APPLICATION NO.	FILING DATE	FIRST NAMED INVENTOR	ATTORNEY DOCKET NO.	CONFIRMATION NO.
10/735,529	12/12/2003	Jon Robert Scott	13869.40	1584
22913	7590	07/14/2004	EXAMINER	
WORKMAN NYDEGGER (F/K/A WORKMAN NYDEGGER & SEELEY) 60 EAST SOUTH TEMPLE 1000 EAGLE GATE TOWER SALT LAKE CITY, UT 84111			SZUMNY, JONATHON A	
		ART UNIT	PAPER NUMBER	
		3632

<b>Office Action Summary</b>	Application No.	Applicant(s)
	10/735,529	SCOTT ET AL.
	Examiner Jon A Szumny	Art Unit 3632

This is the first office action for application number 10/735,529, Support Apparatus or Accessory for Ladder, filed on December 12, 2003.

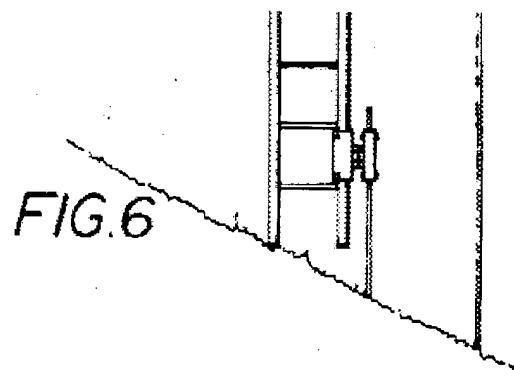
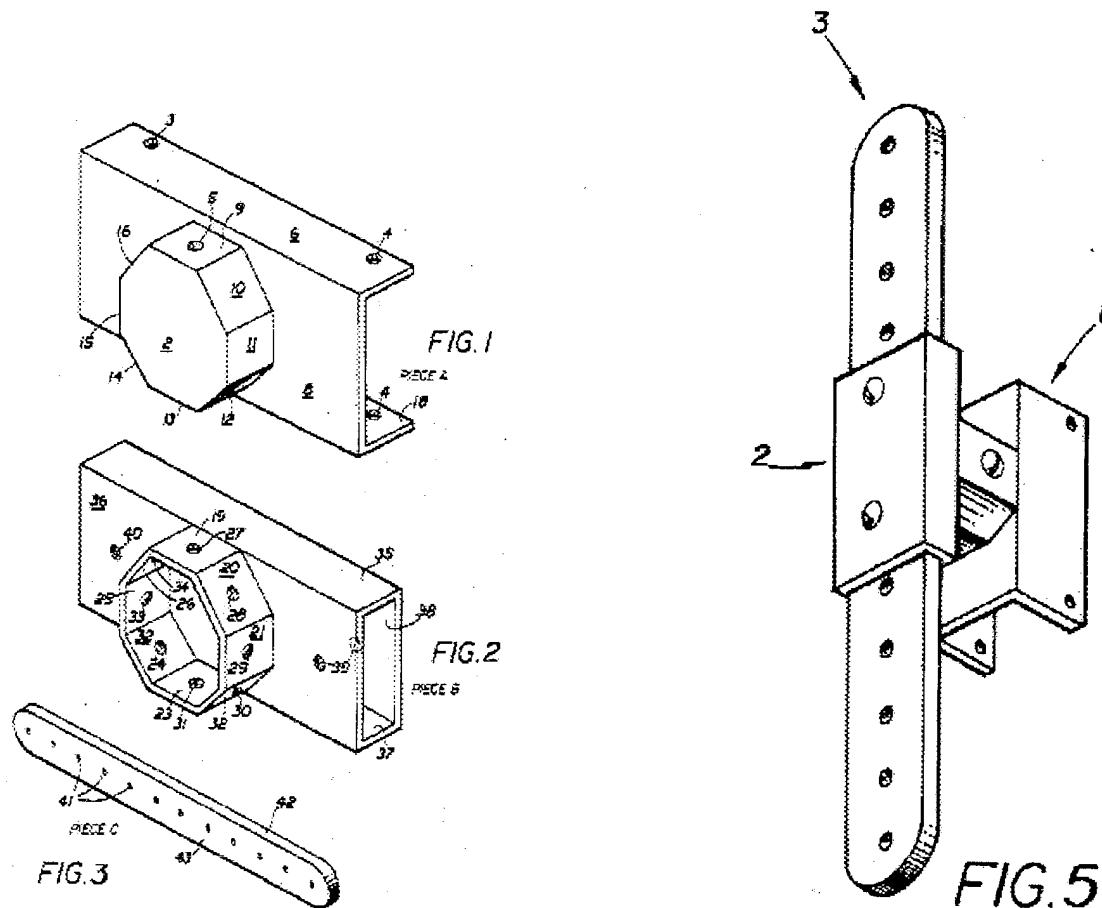
Claims 1-8, 10, 14, 15 and 21-24 are rejected under 35 U.S.C. 102(b) as being anticipated by U.S. Patent number 4,284,172 to Cohen.

Cohen '172 discloses a support apparatus (above) including a body (35-38, 42, 43), a primary attachment member (19, 20, 21, etc) connected to the body/adjustable length body, a secondary attachment member (6, 8, 9, 10, 11, etc.) secured to a side rail of a ladder, and locking means (bolt, see column 2, lines 25-37), wherein the body comprises a fixed component (35-38) to which the primary attachment member is connected and a movable component (42,43) capable of moving relative to the fixed component, wherein the fixed component comprises guiding means (within 35-38) in the form of a channel/housing/elongate continuous enclosed hollow tube, wherein the movable component is an inner member capable of telescopic movement relative to the housing, wherein the movable component is securable at a desired position relative to the fixed member by securing means comprising a securing pin (column 2, line 46) located on the fixed component (when attachment members are engaged) and a mating aperture (41) located on the movable component, wherein the securing pin when inserted into the mating aperture secures the movable component relative to the fixed component, wherein the primary and secondary attachment members engage in a male-female interaction, wherein the primary attachment member is a socket and the secondary attachment member is a peg.

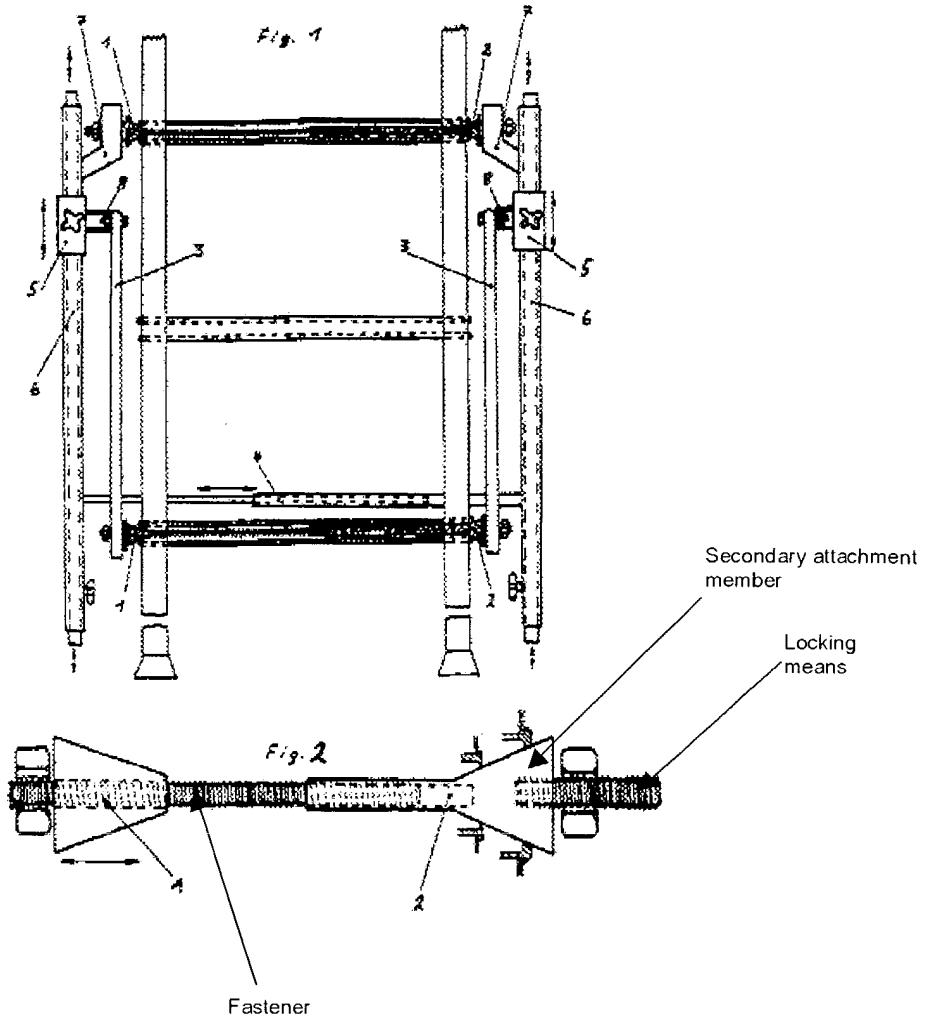
Claims 1 and 10-13 are rejected under 35 U.S.C. 102(b) as being anticipated by U.S. Patent number 6,382,353 to Laug.

Laug '353 discloses a support apparatus (figures 1,2) including a body (5,6), a primary attachment member (7) connected to the body/adjustable length body, a secondary attachment member (above) secured to a side rail of a ladder, and locking means (above), wherein the secondary attachment member is secured by a fastener (above) that is adapted to extend at least through the side rail of the ladder, wherein the fastener is a rod adapted to traverse the ladder from one side rail to another side rail, wherein the rod is adapted to be located within an adjacent rung of the ladder.
